SECTION 00 91 13
ADDENDA

ADDENDUM:	<u>No. 2</u>
ADDENDUM DATE:	<u>August 26, 2024</u>
BID DATE:	<u>August 29, 2024</u>

This **ADDENDUM** is issued to institute the included changes and/or deletions to the Plans and Specifications for the **IFB# 026-45 HALL COUNTY-SPOUT SPRINGS WATER RECLAMATION FACILITY EXPANSION TO 1.6 MGD** project and hereby becomes a part of said Plans and Specifications.

**ENLARGED PROPOSED
 YARD PIPING PLAN 3**

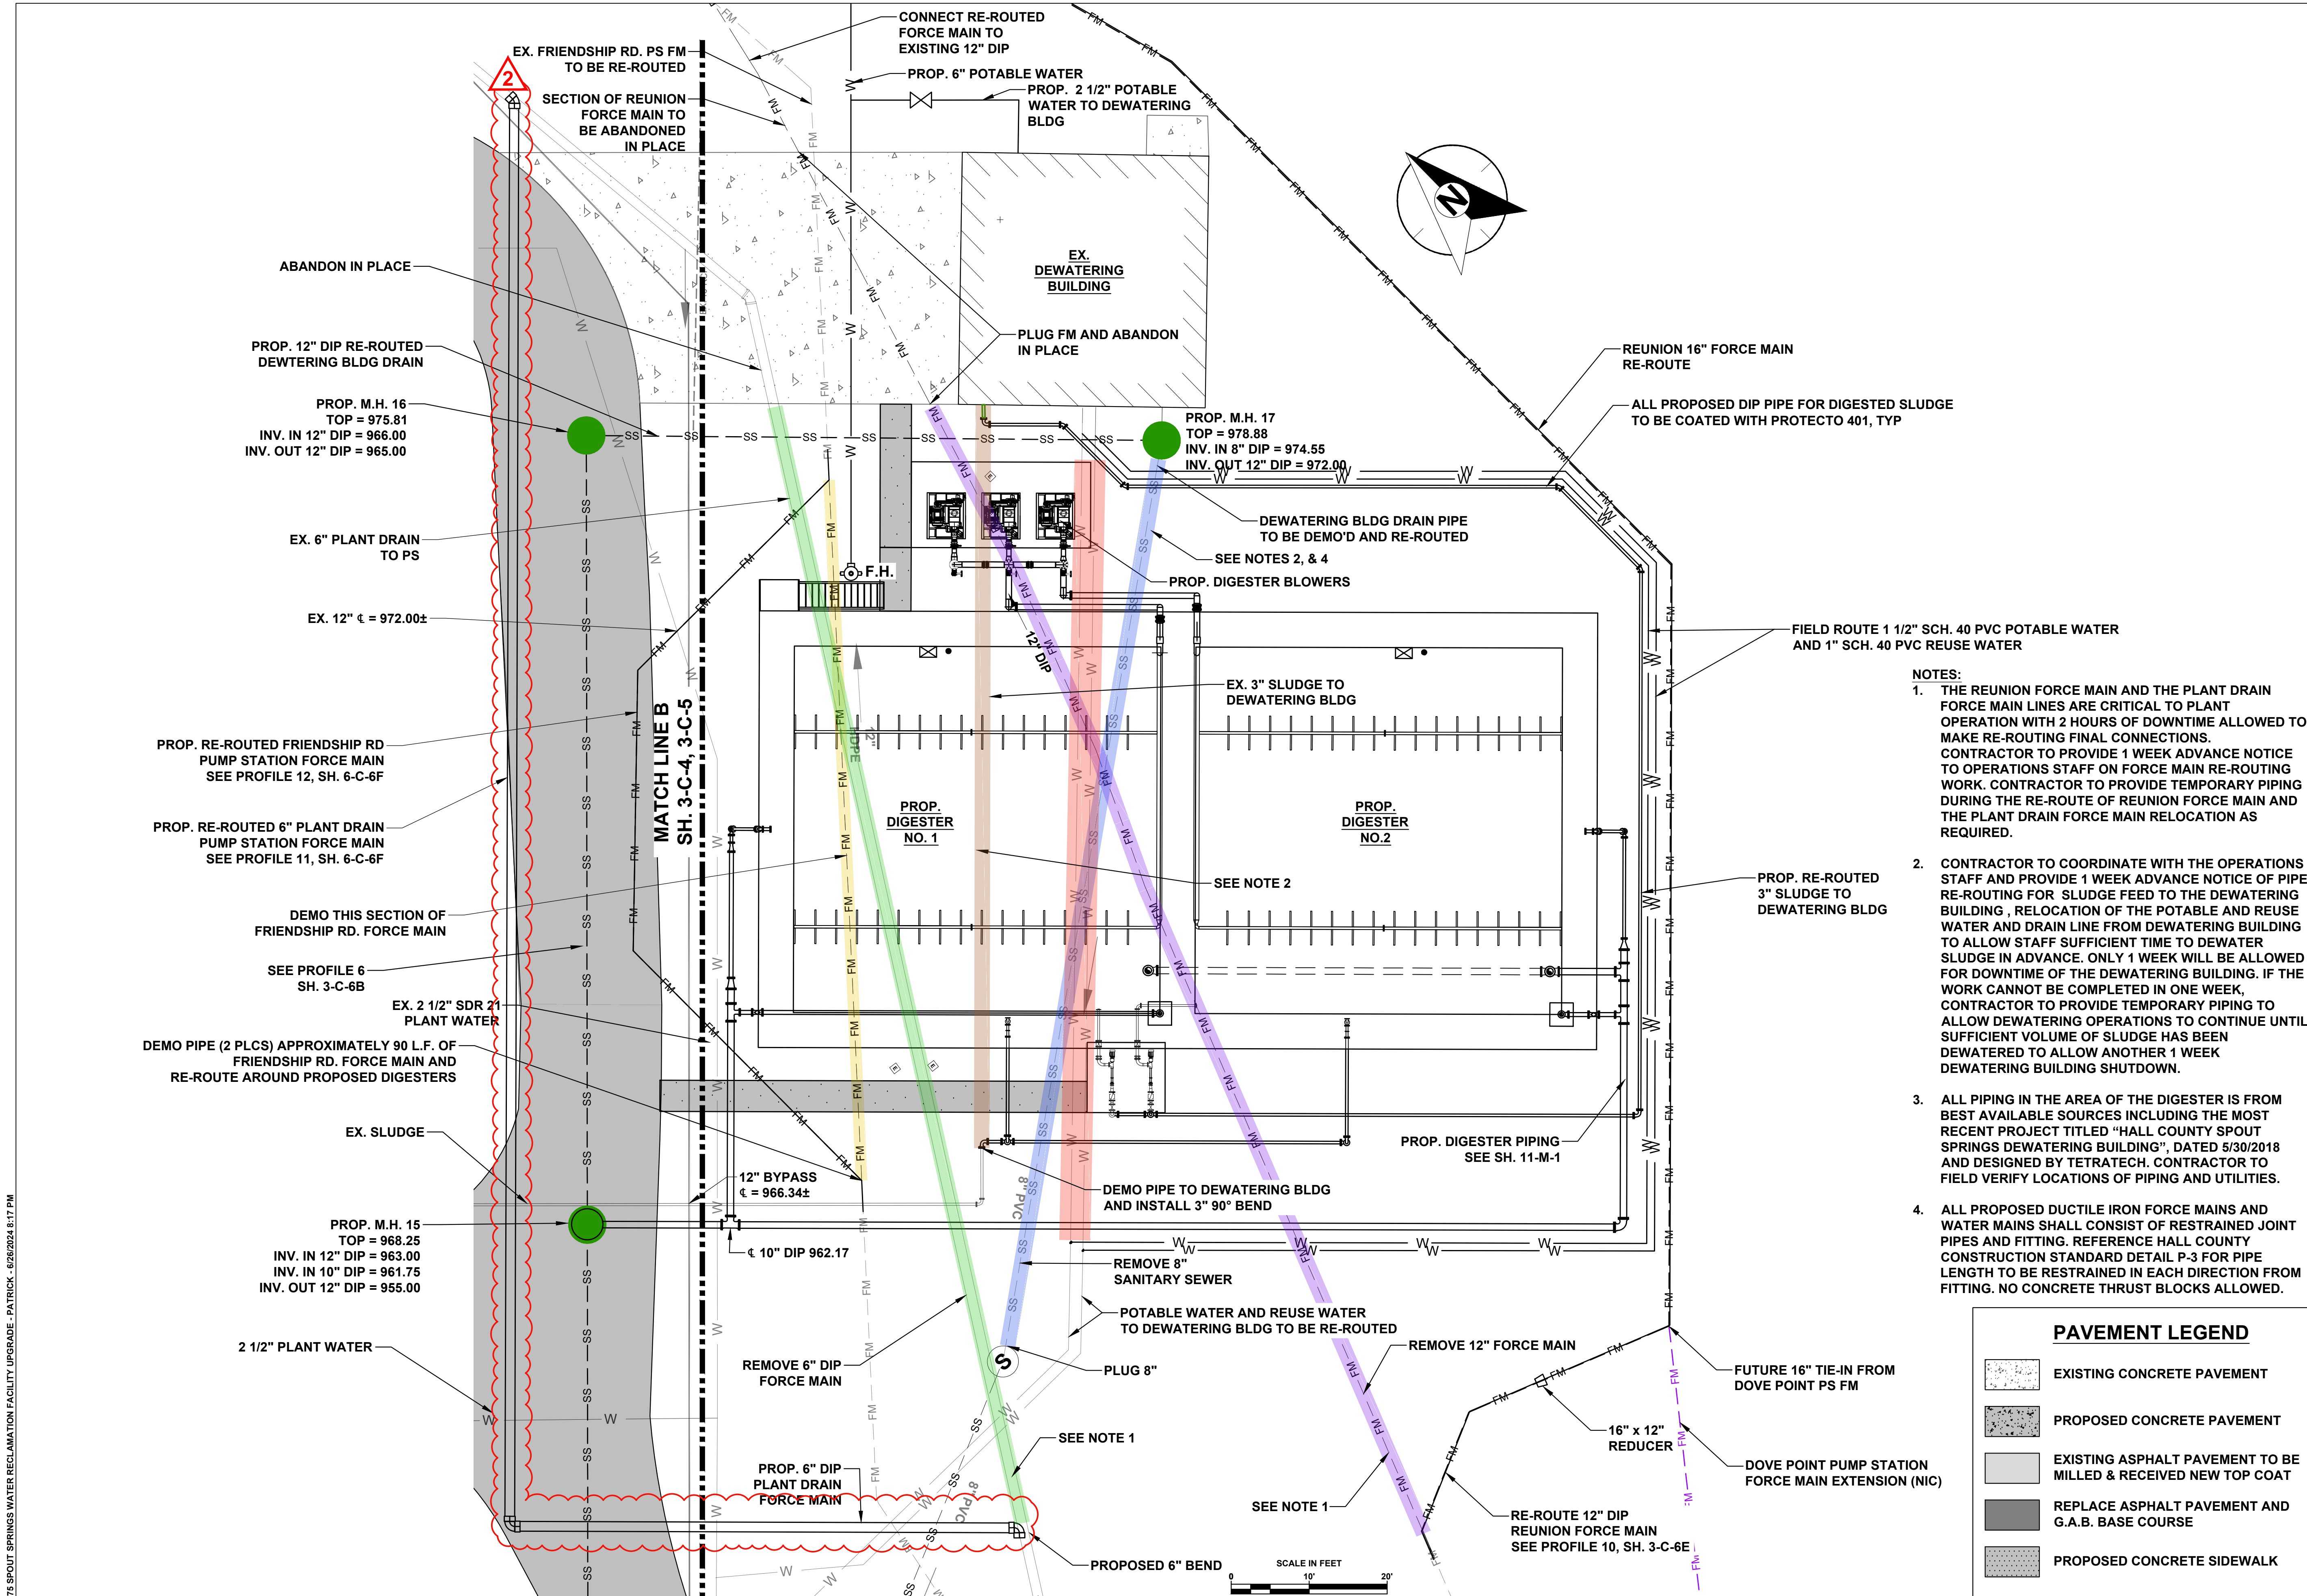
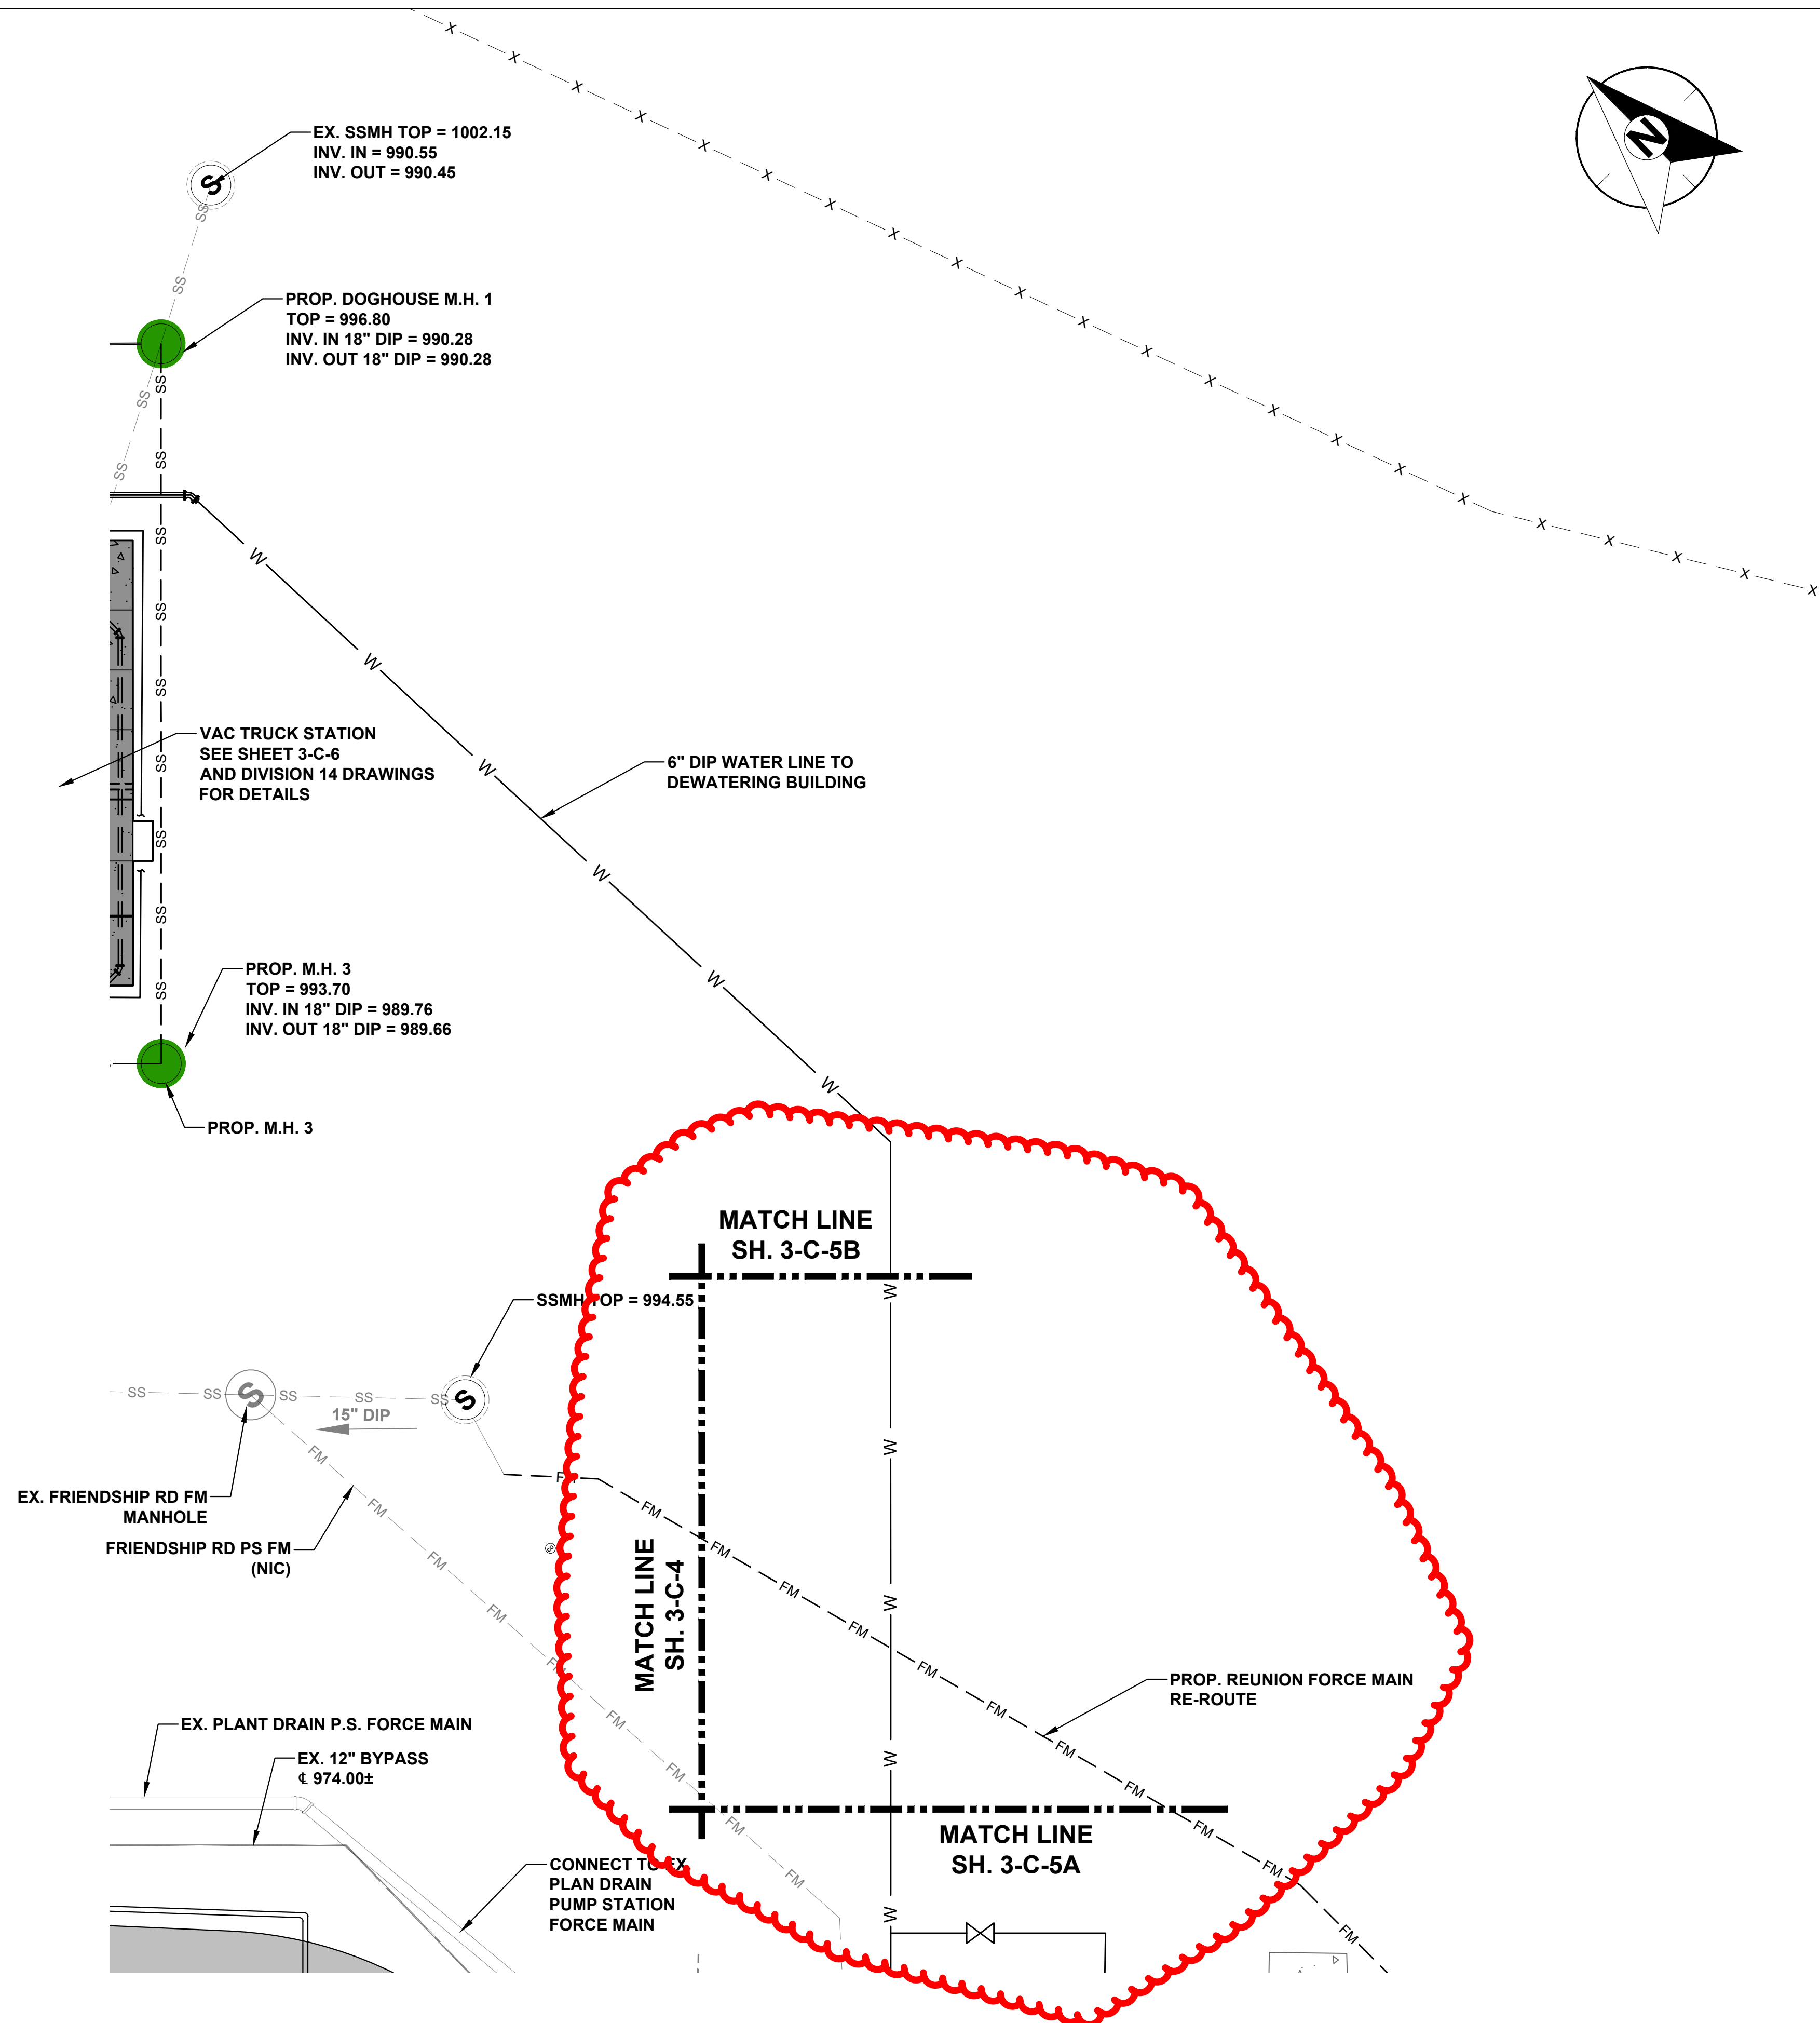
16. Drawing 3-C-4 calls out “CONNECT TO EX. PLAN DRAIN PUMP STATION FORCE MAIN” (near match line on right side of drawing) but the piping is not bold and appears to be existing. A little farther down on the pipeline closer to the match line another call out states “ABANDON IN PLACE”. Then on Drawing 3-C-5A the pipe is highlighted green and a note calls out “EX. 6” PLANT DRAIN TO PS”, but the pipe is drawn as a much larger pipe. Towards the bottom a note states “PROPOSED 6” BEND” but there is nothing there. The scope of work is very unclear and appears a layer or more of the drawing file was left off/hidden when plotting to PDF. Please provide revised drawings showing the piping scope.

17. Drawing 3-C-4 appears to show new piping connecting to existing south/west of the Headworks (Headworks Effluent and Plant Drain PS Force Main), but there are no call outs, and nothing is shown on 6 series drawings. Please confirm the bold lines on the existing piping is not indicating any “new” work for this contract.

18. Drawing 3-C-4 calls out Prop. Reunion Force Main Re-Route and appears to show a dashed bold line connecting to a lighter line weight pipe outside an existing SS MH. The existing piping that will not be in service after the re-route is not shown. Please clarify scope (abandon or remove). If removal, please provide drawing showing routing.

Drawings 3-C-4 and 3-C-5A have been revised. See attached.

Connect the re-routed reunion force main to the existing force main (12-inch) just outside the existing manhole. A reconnect note is shown at the top of Drawing 3-C-5A.
